CIVIL AVIATION AUTHORITY OF NEW ZEALAND

AIRWORTHINESS DIRECTIVES

Amendment Nr 26-08

Effective date 3 September 2026

Figure: Airbus Helicopters recommended CG position of forward two-place seat

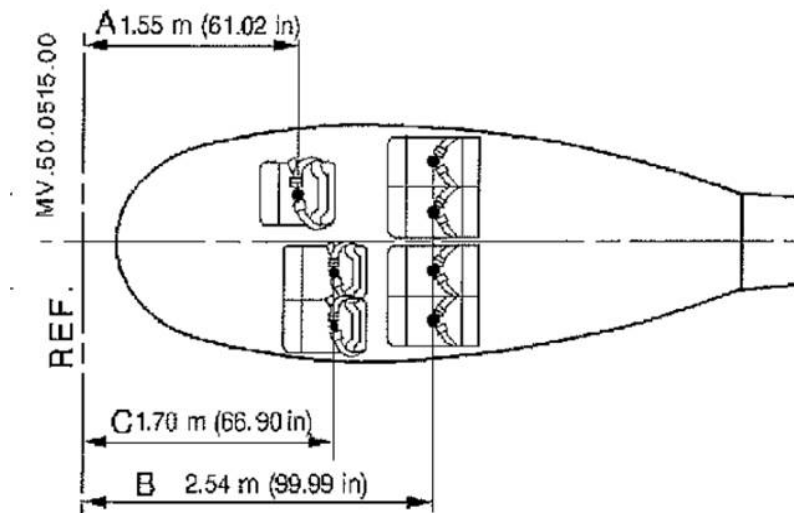
2. Remove CAA Limitations Section, (1 page), dated 14 December 2015 and insert 1 page dated 30 June 2016.

- Compliance:**
1. Before further use of the forward two-place seat, unless previously accomplished.
 2. Before further use of the forward two-place seat.

Figure: Airbus Helicopters recommended CG position of forward two-place seat.

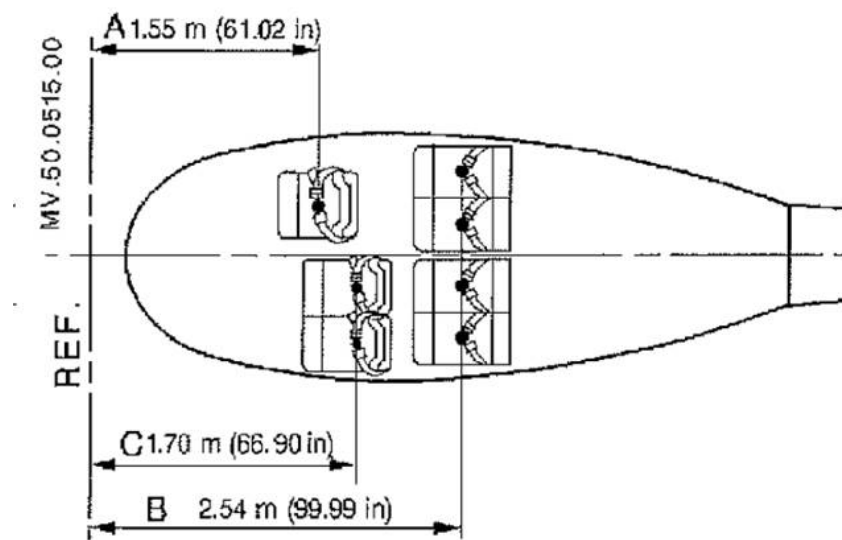
Annotate the CAA2173 to include the value of the longitudinal moment arm of the forward two-place seat used.

2. Remove CAA Limitations Section, (1 page), dated 14 December 2015 and insert 1 page dated 30 June 2016.

DCA/SEAT/6 Safety Belt Assemblies - Removal

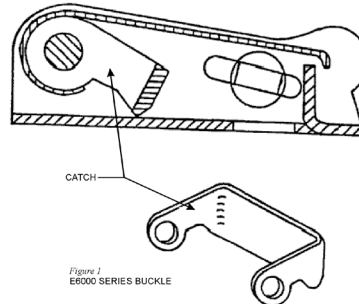
Requirement: To prevent inadvertent opening of safety belt assemblies accomplish the following:

Note: Buckle assembly concerned has a front cover plate which is pivoted at one end and is pulled through an arc at the other end to release the latch from the buckle. The E6000 buckle can be identified by the type of catch used. Figure 1 (following) shows the catch configuration and its location within the buckle assembly.

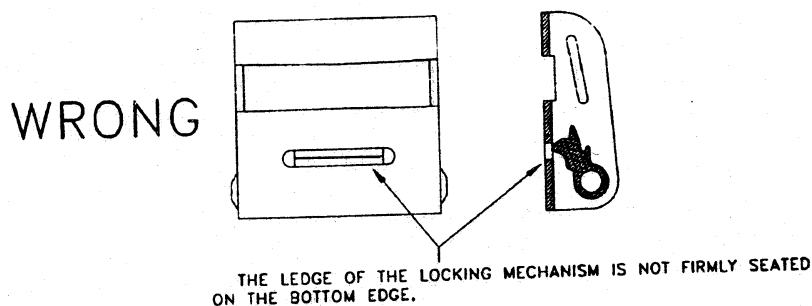
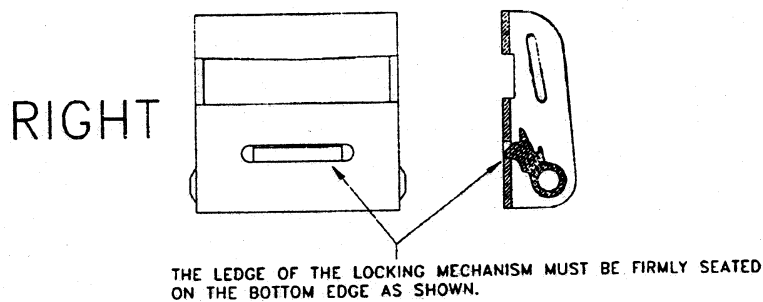
Requirement: To prevent failure of the seat restraint system due to the buckle assembly locking mechanism not engaging properly, which could result in the restraint system failing to properly secure the occupant during turbulence or landing, accomplish the following:

Visually inspect all affected seat restraint systems to determine if the locking mechanism is engaging properly per the following:

Open the lift lever of the buckle fully until it will not open any further. This will cause the locking mechanism to pivot on the pivot pin.

After the lever is completely closed, examine the slot in the bottom of the buckle. The locking mechanism should be firmly seated against the edge of the slot as shown in Figure 1.

DCA/YAK/5 Elevator Control System Pulley – Inspection

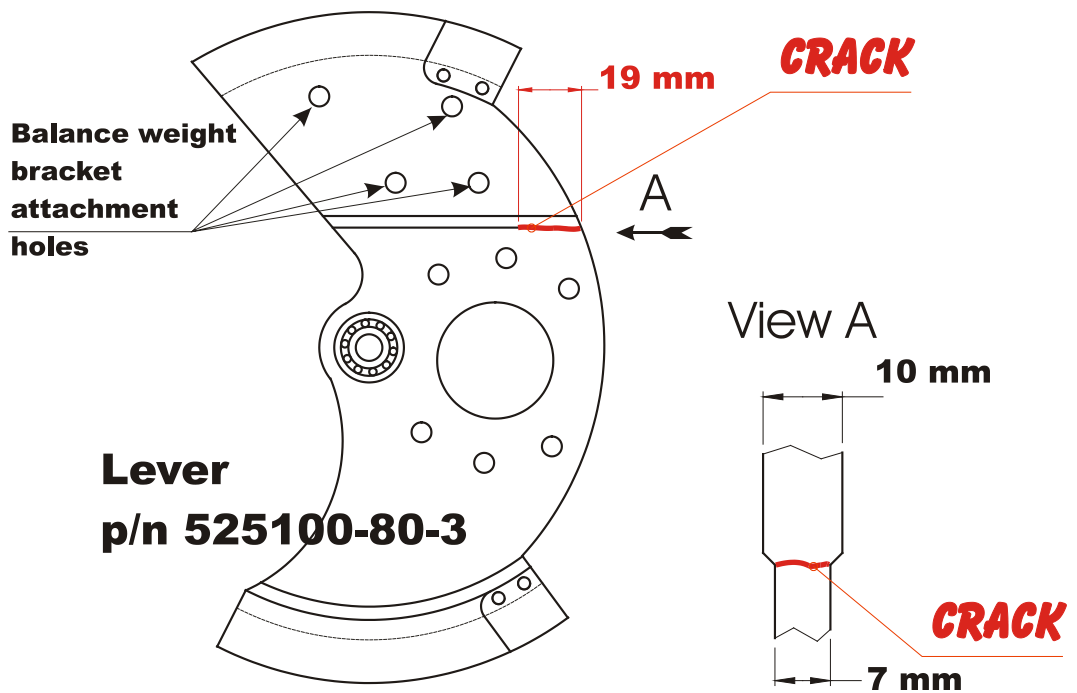
Note: This AD is prompted by a report of finding a 19 mm crack in the elevator control pulley P/N 525100-80-3 (referred to in the Romanian parts catalogue as a “lever”). The failure of this component could result in loss of elevator control.

Requirement: To prevent failure of the elevator balance weight flange/sector/lever P/N 525100-80-3 which could result in loss of elevator control, accomplish the following:
